HARTZELL PROPELLER INC.

# ALERT SERVICE BULLETIN

HC-ASB-30-358

## Anti-ice - Travel Tube Bracket Weldment Replacement

**104714 Bracket Weldment Inspection**  
**Figure 1**

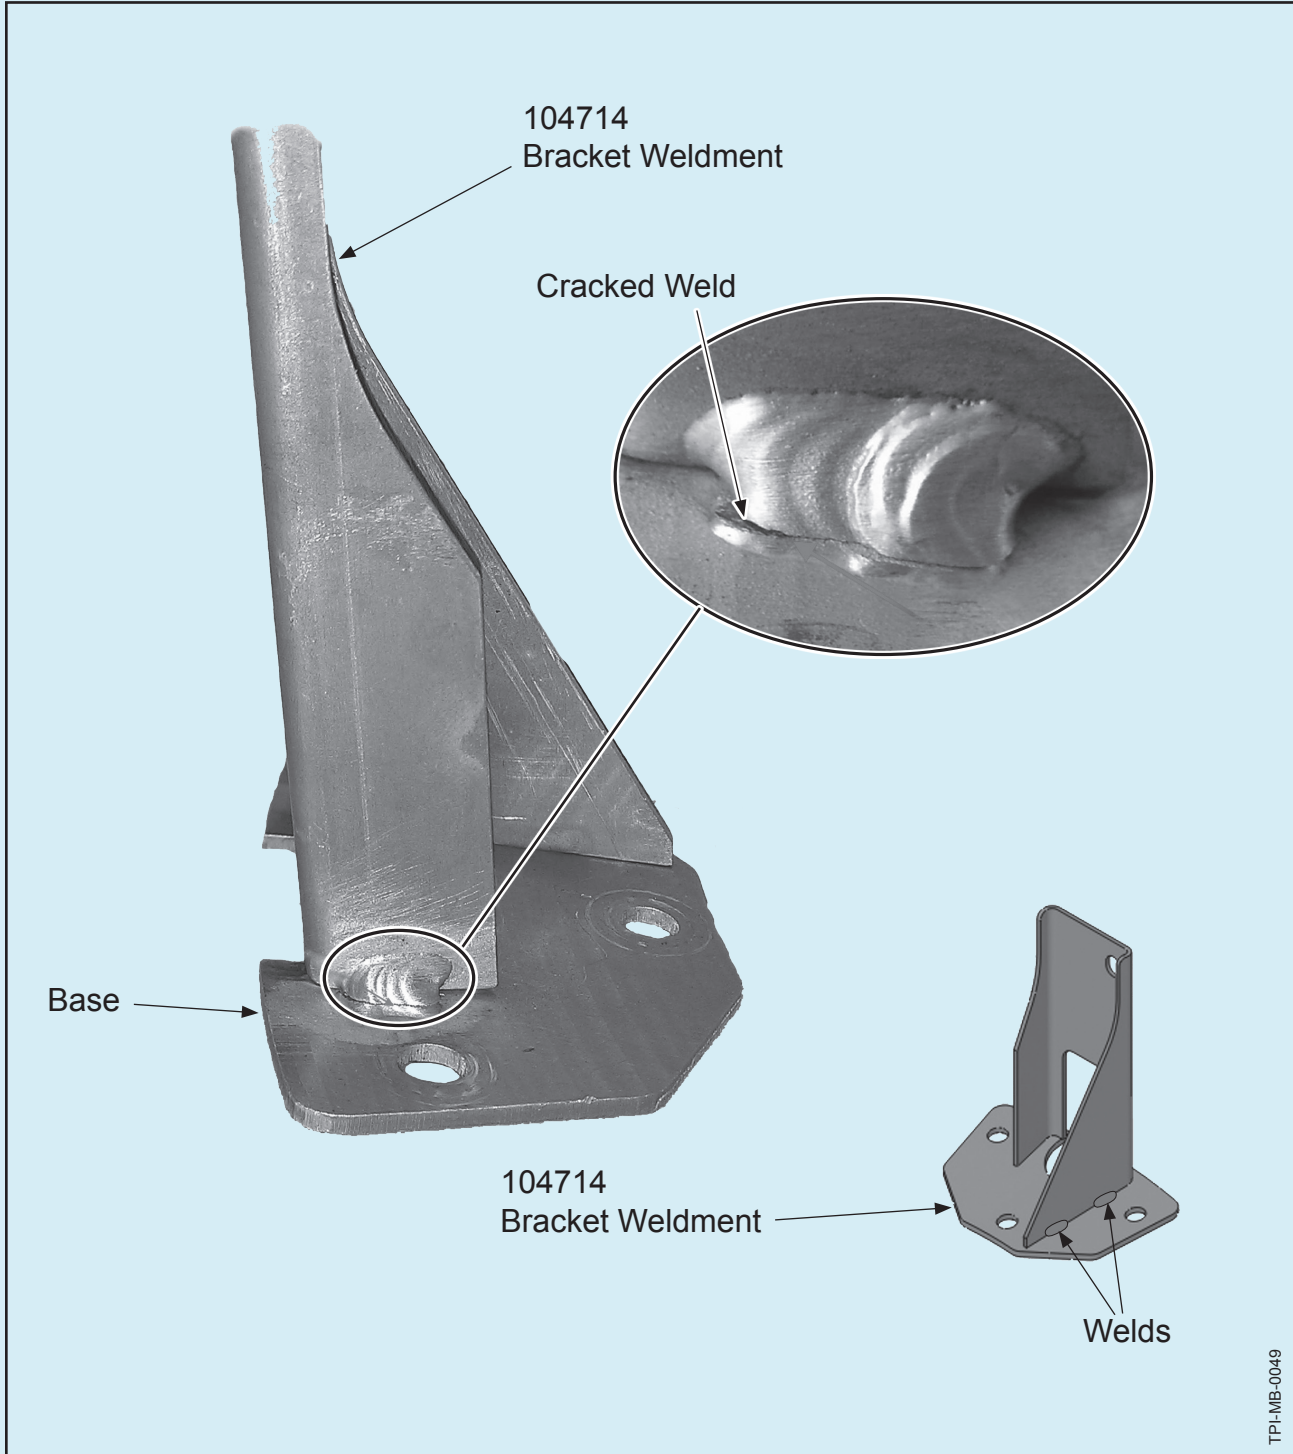
- (2) Remove the spinner dome in accordance with Hartzell Propeller Inc. Owner's Manual 139 (61-00-39).
- (3) Examine each 104714 bracket weldment on the affected propeller for cracked or broken welds at the base of the bracket. Refer to Figure 1.

- (a) If none of the 104714 bracket weldments have any cracked/broken welds, the propeller **passes** the bracket weldment inspection.
  - (b) If any of the 104714 bracket weldments have one (but no more than one) cracked/broken weld, the propeller **fails** the bracket weldment inspection.

- 1 If the cracked/broken weld is still securing the upper portion of the bracket to the base:
      - a Within 50 flight hours of the bracket weldment inspection, replace all three bracket weldments in accordance with section 3.B. of the Accomplishment Instructions in this Alert Service Bulletin.

- 2 If the cracked/broken weld has caused separation between the upper portion of the bracket and the base:
      - a Contact the Product Support Department at Hartzell Propeller Inc. before further flight.

- (c) If any of the 104714 bracket weldments have two or more cracked/broken welds, the propeller **fails** the bracket weldment inspection.
    - 1 Contact the Product Support Department at Hartzell Propeller Inc. before further flight.

**Disconnecting the Link Arm from the Piston Unit**  
**Figure 2**

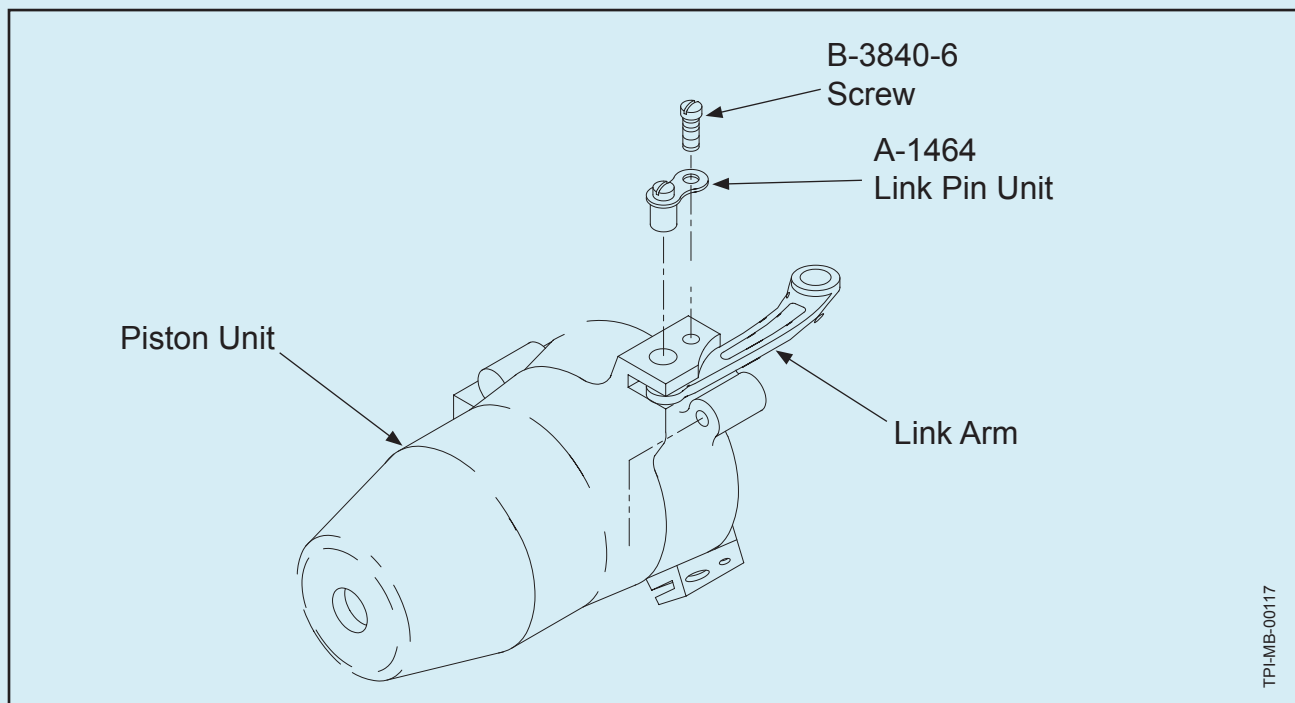
- (1) This procedure may be performed on-wing by a certified aircraft mechanic with the appropriate rating or by a certified propeller repair station with the appropriate rating.
- (2) Remove the spinner dome in accordance with Hartzell Propeller Inc. Owner's Manual 139 (61-00-39).
- (3) Open the upper right cowling door and remove the right nose cap in accordance with the airframe manufacturer's maintenance manual (AMM).
- (4) Disconnect the three link arms from the piston unit. Refer to Figure 2.

- (a) Cut and remove the safety wire securing the B-3840-6 screw to the A-1464 link pin unit.
- (b) Remove and retain the B-3840-6 screw and the A-1464 link pin unit.
- (c) Repeat steps 3.B.(4)(a) and 3.B.(4)(b) for each link arm.

**Removing the 104714 Bracket Weldment  
Figure 3**

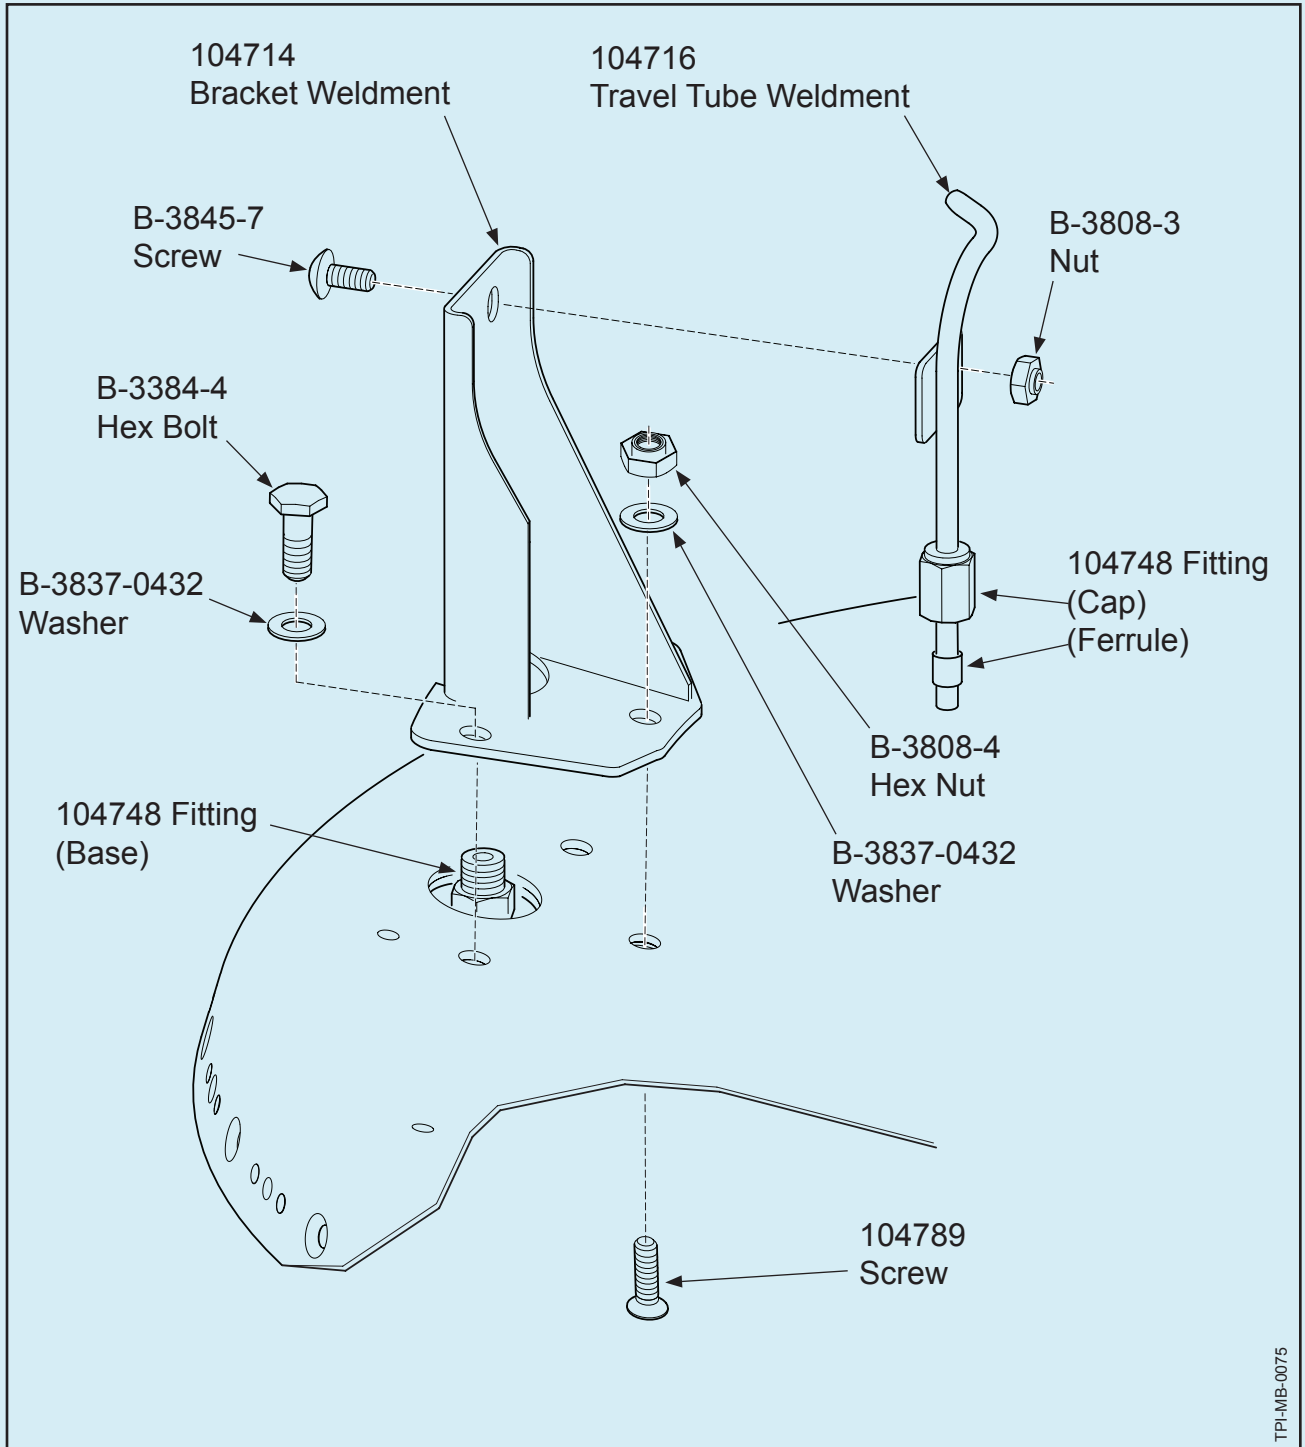
- (5) Remove the 104716 travel tube weldment from the 104714 bracket weldment. Refer to Figure 3.
  - (a) Holding the base of the 104748 fitting to prevent rotation, loosen the cap of the 104748 fitting until it separates from the base.

- 1 Do not remove the cap and ferrule of the 104748 fitting from the 104716 travel tube weldment. These components will be reused.
- (6) Remove and discard the 104714 bracket weldment. Refer to Figure 3.

- (b) Remove and discard the B-3845-7 screw and the B-3808-3 nut from the 104714 bracket weldment.
  - (c) Remove the 104716 travel tube weldment from the base of the 104748 fitting.

- (a) Remove and discard the two B-3384-4 hex bolts and two B-3837-0432 washers.
  - (b) Remove and discard the B-3808-4 hex nut, B-3837-0432 washer, 104789 screw, and the 104714 bracket weldment.

**Installing the 106107 Anti-ice Bracket  
Figure 4**

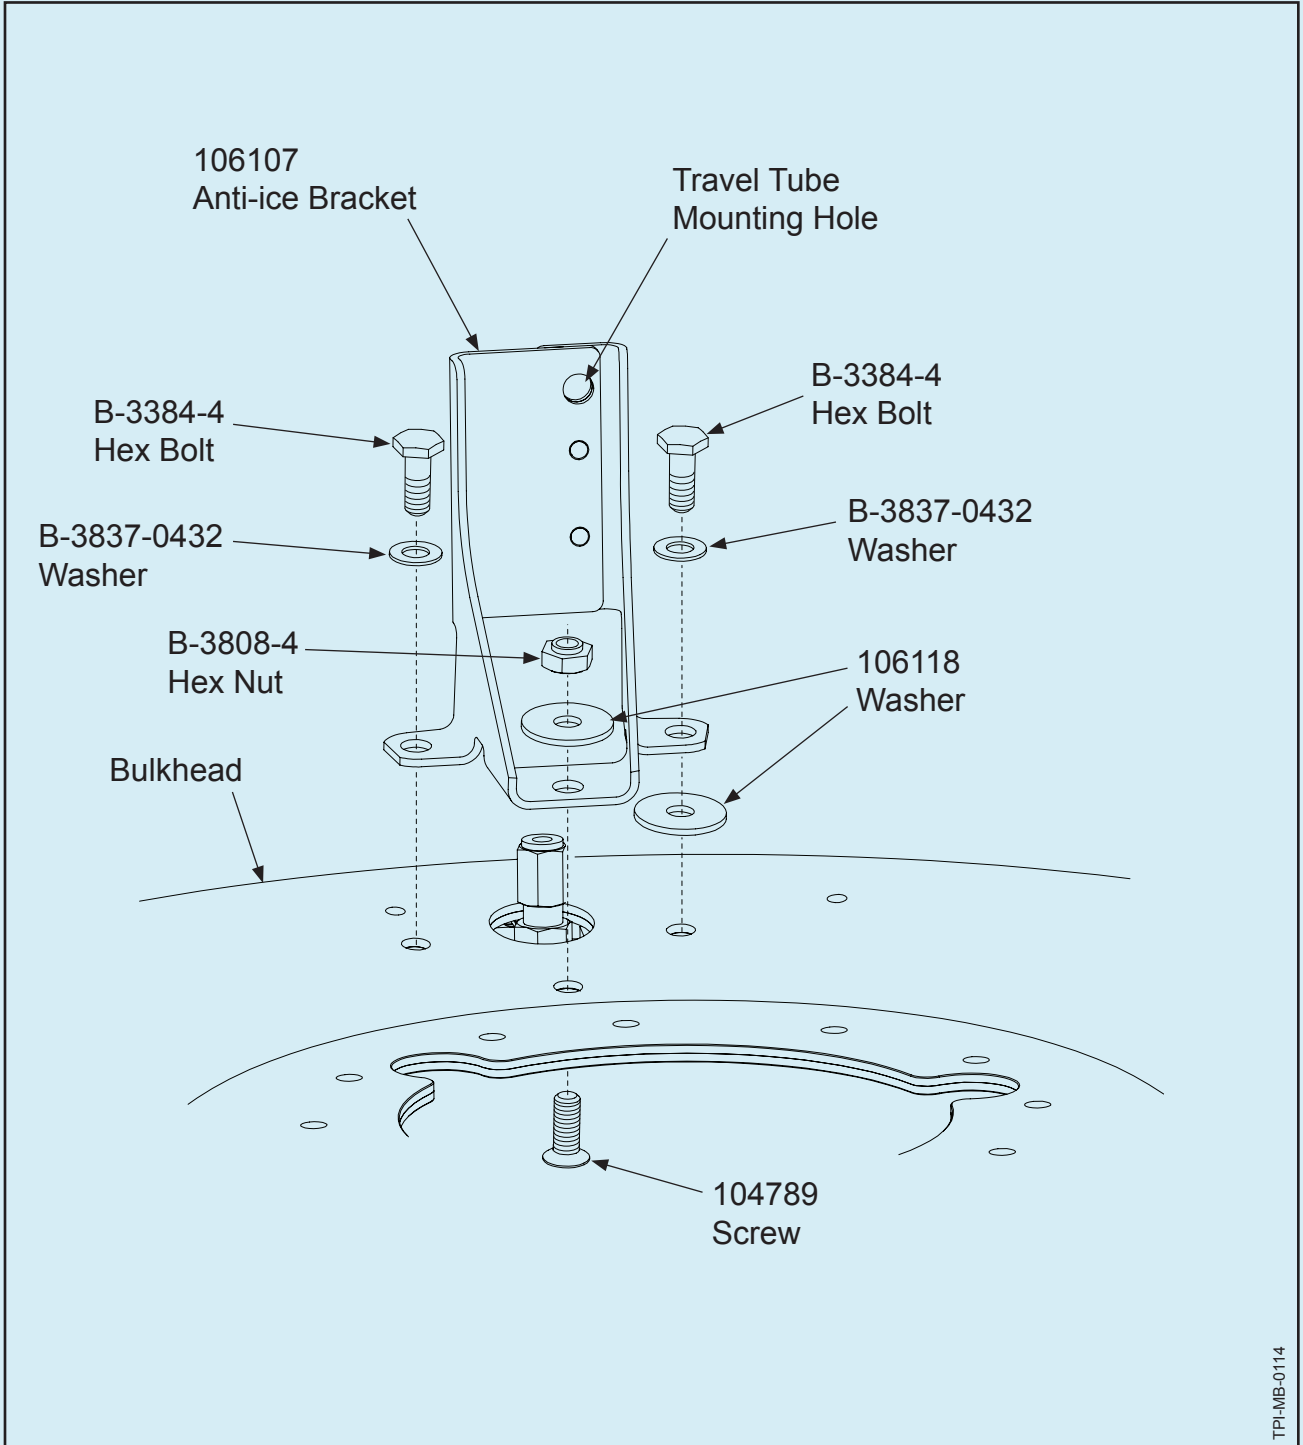
- (7) Install the 106107 anti-ice bracket. Refer to Figure 4.
  - (a) Align the mounting holes in the 106107 anti-ice bracket with the mounting holes in the bulkhead.

- (b) Put one 106118 washer under the 106107 anti-ice bracket on the same side as the travel tube mounting hole as shown in Figure 4.
  - (c) Apply Loctite 222 CM21 to the threads of the two B-3384-4 hex bolts.

- (d) Install two B-3384-4 hex bolts and two B-3837-0432 washers through the two outer mounting holes in the 106107 anti-ice bracket.

- 1 Manually rotate the blade as necessary for access to install the two B-3384-4 hex bolts.
- (e) Install the 104789 screw from the aft-side of the bulkhead through the inner mounting hole of the 106107 anti-ice bracket, then install the 106118 washer and B-3808-4 hex nut.
  - 1 Torque the B-3808-4 hex nut to 70 - 85 In-Lbs (8.0 - 9.6 N•m).
    - a If necessary, use a 7/16 inch crowfoot wrench to torque the B-3808-4 hex nut. Refer to Figure 5.
